SERVICE BULLETIN SB99.1

LX31/41/50 with Kubota D905 and WG750 engines.

PURPOSE: To insure proper torque on HECO torque hubs.

OPERATION REQUIRED: Replace bolts assembling the torque hub.

FIGURE 1

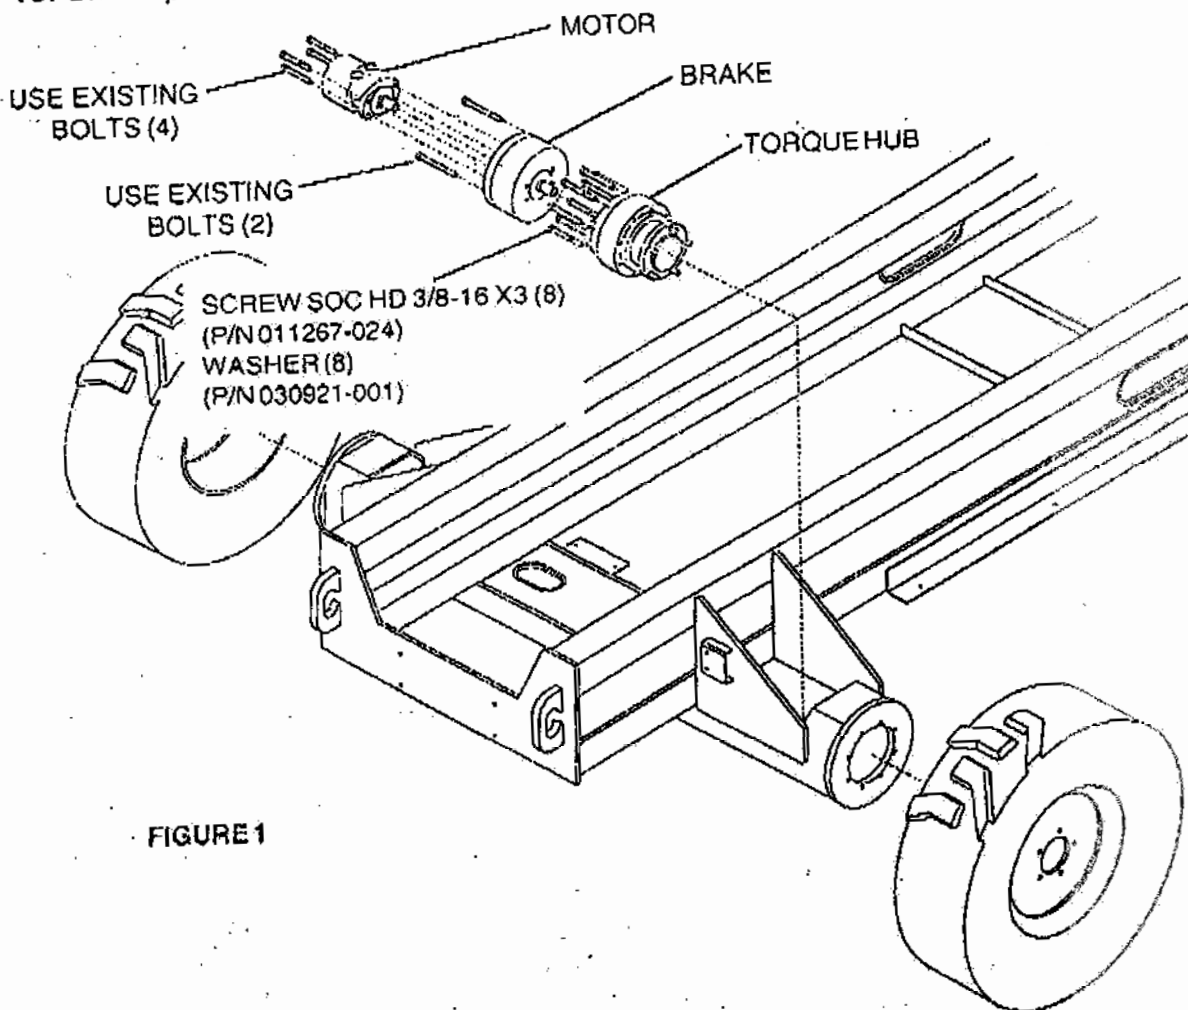
PROCEDURE: Read all instructions thoroughly and refer to figure 1 before starting.

8. Remove two opposite bolts from Torque Hub, discard and install supplied screws (P/N) 011267-024 Screw Soc Hd 3/8 - 16 x 3) and washers (P/N 030921-001 Hardened Washer). Torque to 25 ft./lbs. (34 Nm).
9. Repeat step 8 four times so that all eight bolts have been removed and replaced.
10. Following a star pattern, torque all bolts a second time to 50 ft./lbs (68 Nm).
11. Reinstall Brake Assembly onto Torque Hub using supplied Gasket (P/N 067603-013 - 2 hole), torque to 75 ft./lbs. (102 Nm). Use Loctite 242 for assembly.

12. Reinstall Torque Hub and Brake Assembly into chassis, torque bolts to 75 ft./lbs. (102 Nm). Use Locktite 242 for assembly.
13. Reinstall Motor into Brake Assembly using supplied Gasket (P/N 067603-014 Gasket - 4 hole), torque bolts to 80 ft./lbs. (108 Nm). Use Locktite 242 for assembly.
14. Repeat steps 4 through 13 for the second Torque Hub.
15. Reinstall motor covers.
16. Reinstall rear wheels, torque wheel nuts to 120 -130 ft/lbs (163 - 176 Nm).
17. Remove jack stands from rear of chassis.
18. Check performance of machine.
